**Economic and Social Council**Distr.: General
27 February 2015

World Forum for Harmonization of Vehicle Regulations**Working Party on Passive Safety****Fifty-seventh session**

Regulation No. 127 (Pedestrian safety)**Proposal for the 02 series of amendments to Regulation No. 127 (Pedestrian safety)****Submitted by the expert from the European Commission as Chair of the Task Force on Bumper Test Area within the Informal Working Group on global technical regulation No. 9 Phase 2***

"Figure 5A

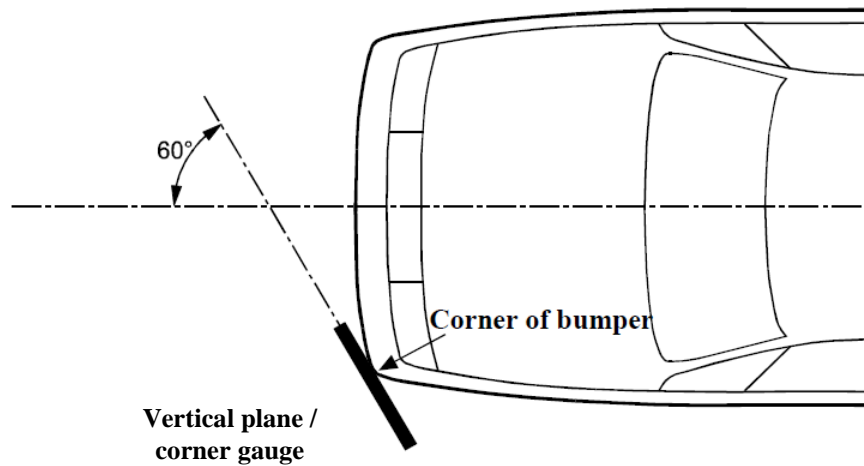
Figure 5, amend to read:

Corner of bumper example (see paragraph 2.17., note that the corner gauge is to be moved in vertical and horizontal directions to enable contact with the outer contour/ front fascia of the vehicle)

"2.17. "Corner of bumper" means the transversal position of the vehicle's point of contact with a vertical plane which makes an angle of 60° with the vertical longitudinal plane of the vehicle and is tangential to the outer surface of the bumper (see Figure 5).corner gauge as defined in Figure 5B.

For determination of the corner of bumper, the front surface of the corner gauge is moved parallel to a vertical plane with an angle of 60° to the vertical longitudinal centre plane of the vehicle (see Figures 5A and 5C) at any height of the centre point of the corner gauge between:

For determination of the corner of bumper, the gauge is moved to contact the outer contour/front fascia of the vehicle touching at the vertical centre line of the gauge. The horizontal centre line of the gauge is kept parallel to the ground plane.

The corners of bumper on both sides are subsequently defined as the outermost points of contact of the gauge with the outer contour/front fascia of the vehicle as determined in accordance with this procedure. Any points of contact on the top and the bottom edges of the gauge are not taken into account. The rear and side view mirrors and the tyres shall not be considered."

Figure 5B

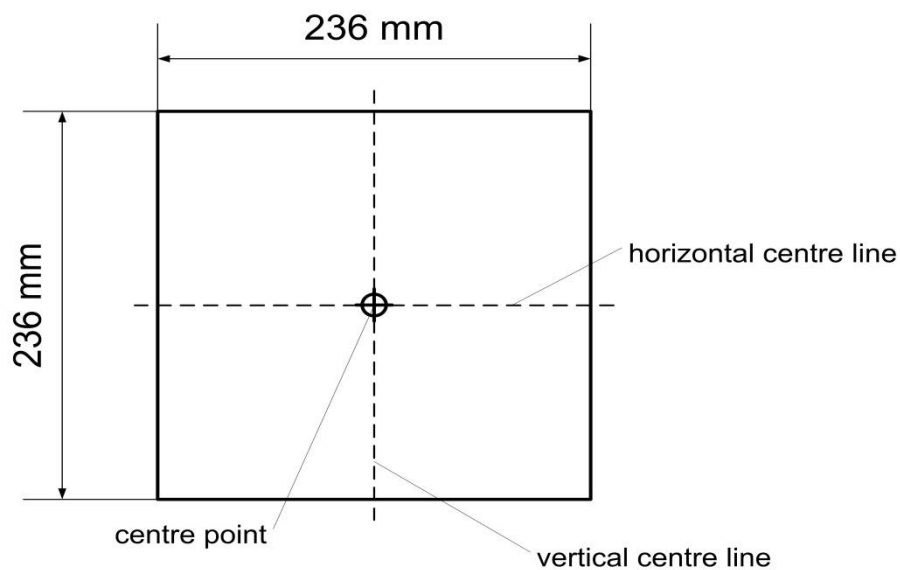
Corner gauge

The front surface of the corner gauge is flat.

The centre point is the intersection of the vertical and horizontal centre lines on the front surface.
